CONSTRUCTION CONTRACT CHANGE ORDER NUMBER: 002

CCSJ: 0912-31-304
Project: STP 1702 (437) MM
Highway: CR 58
County: Brazoria
District: Houston
Contract Number: _____

Removal of Septic Systems and Well

Document Type: Change Order Memorandum
Subject: Change Order 02
Project: 0912-31-304; CR 58
Description: Septic System and Well Removal

REMOVAL
PLAN

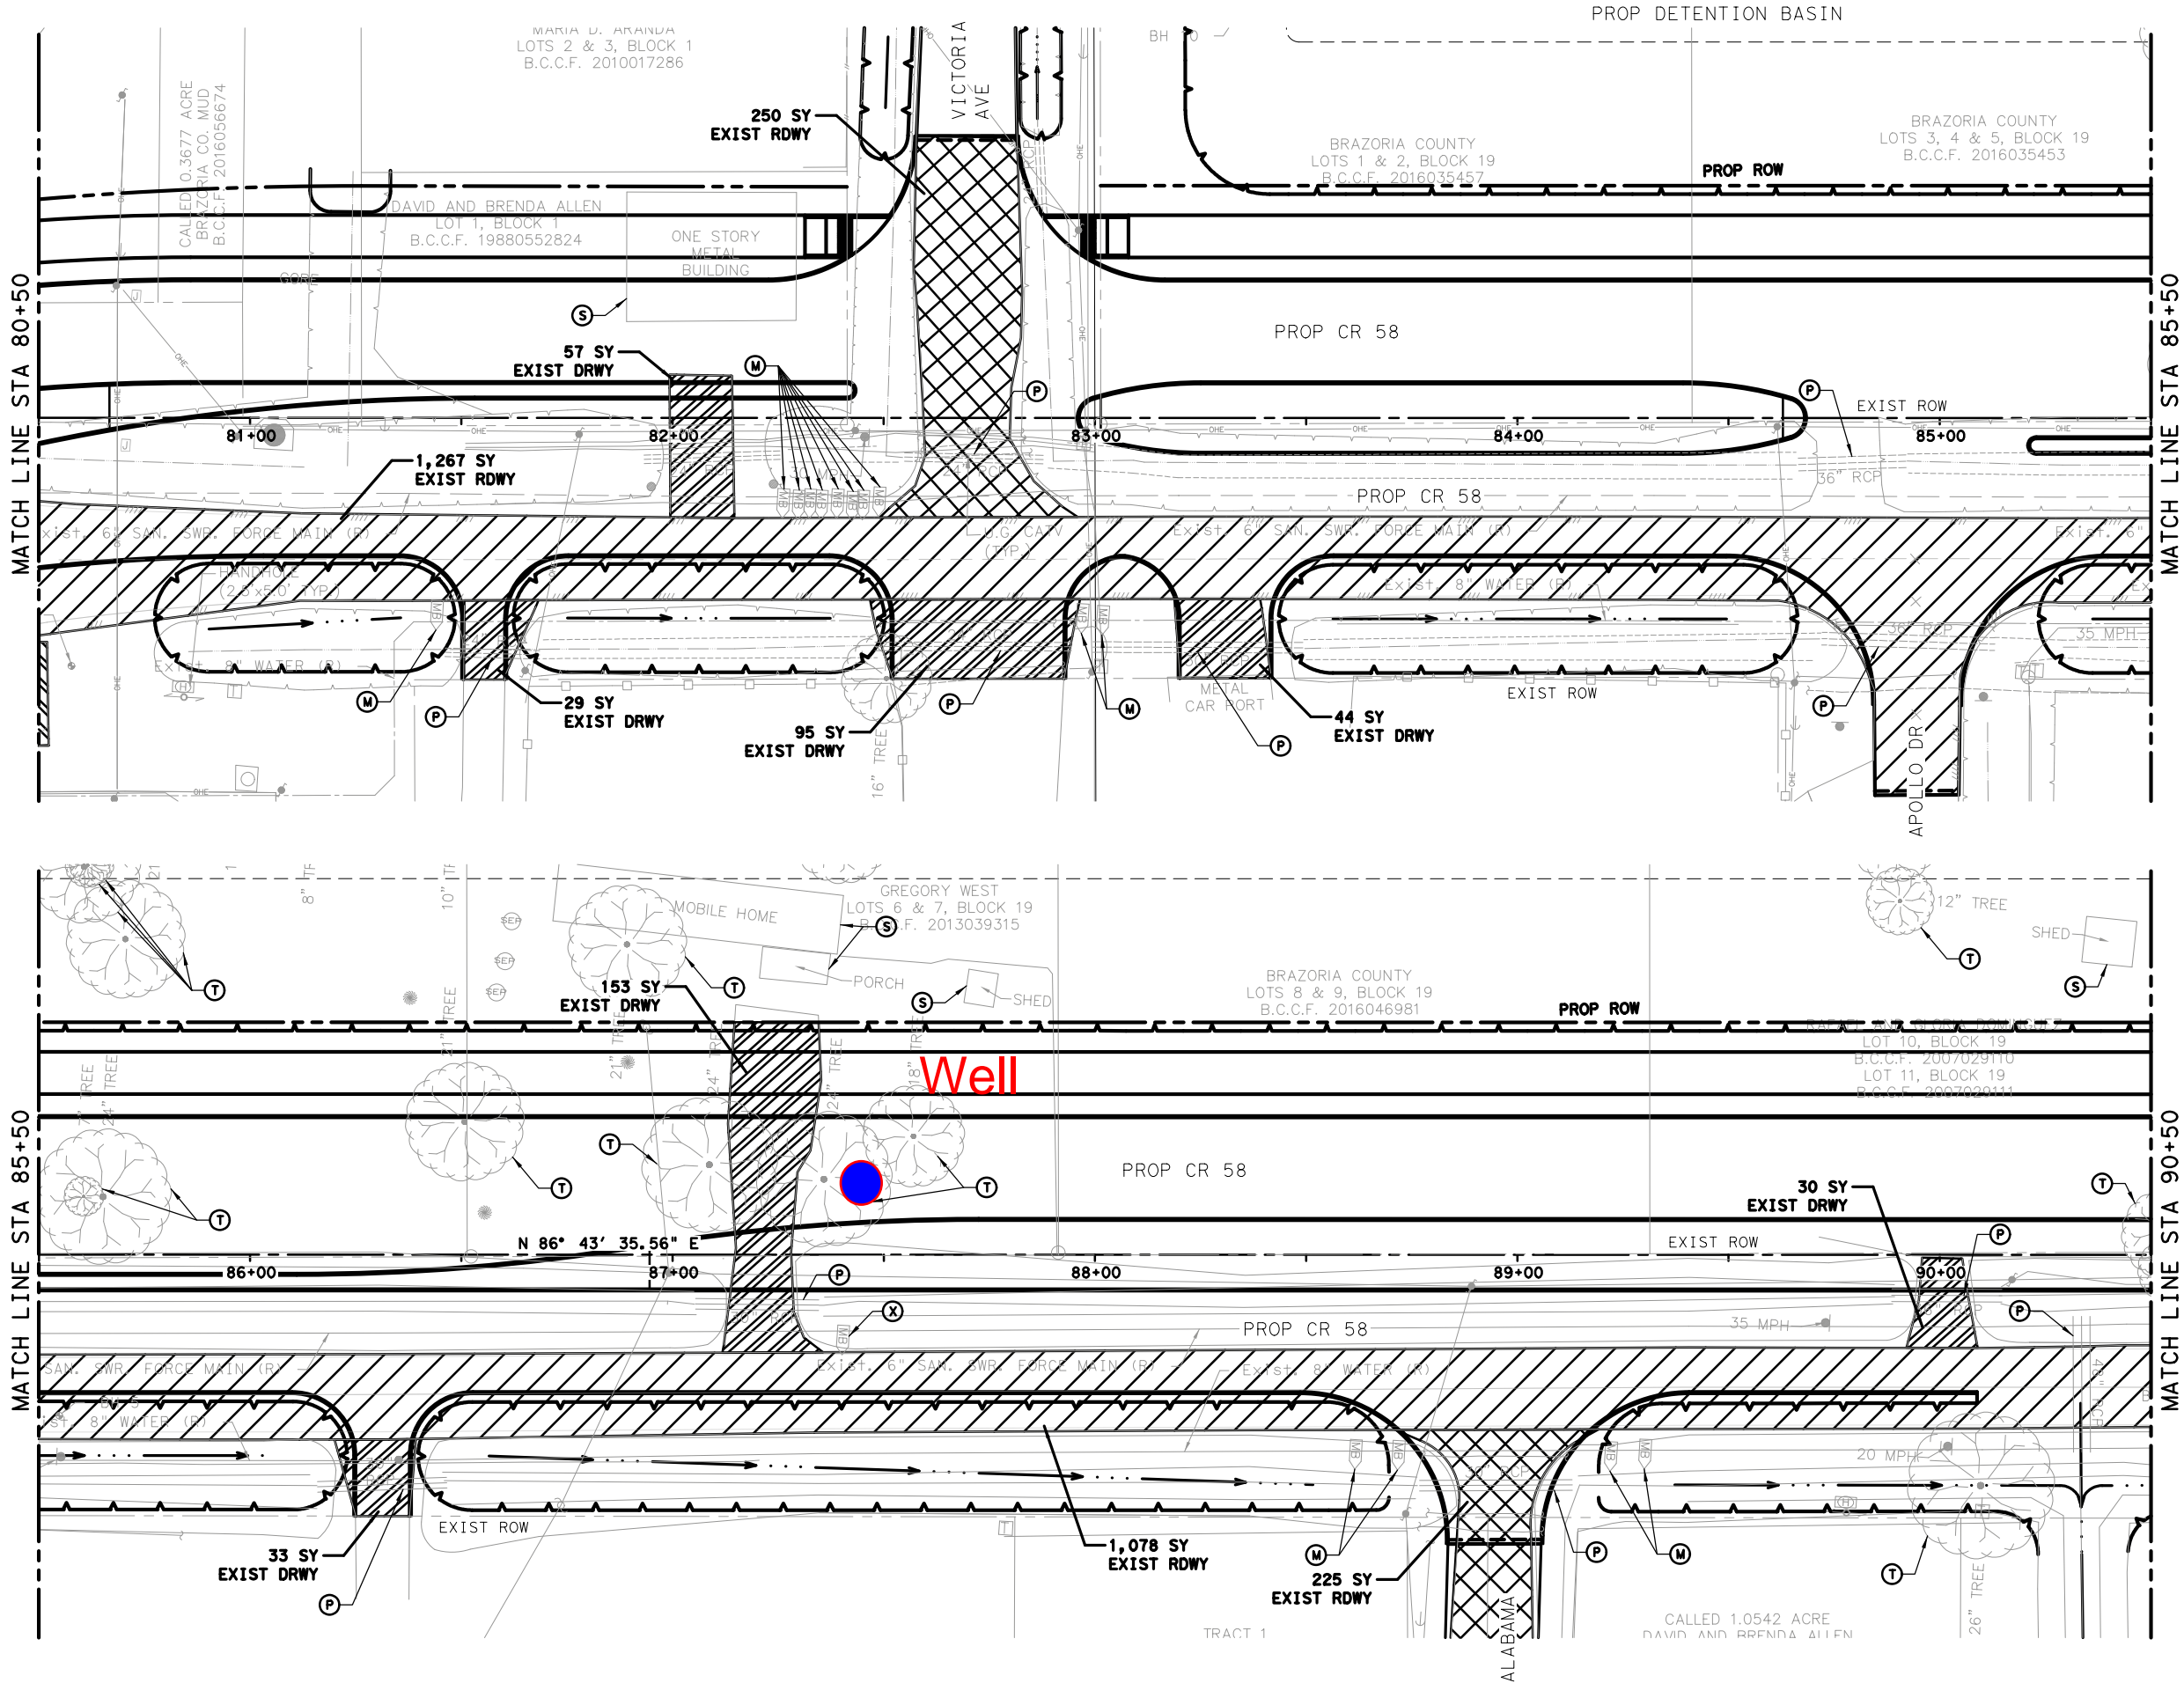
The CR 58 project includes two (2) detention ponds to be installed between Angelina and CR 58. The Contractor started the excavation of the ponds and discovered an old well and an abandoned septic system. The well is located at STA 83+50 while the septic system is located at STA 99+00. The attached removal plan sheets show these approximate locations. These items need to be removed to complete the project, therefore this change order adds a work item to complete the removal.
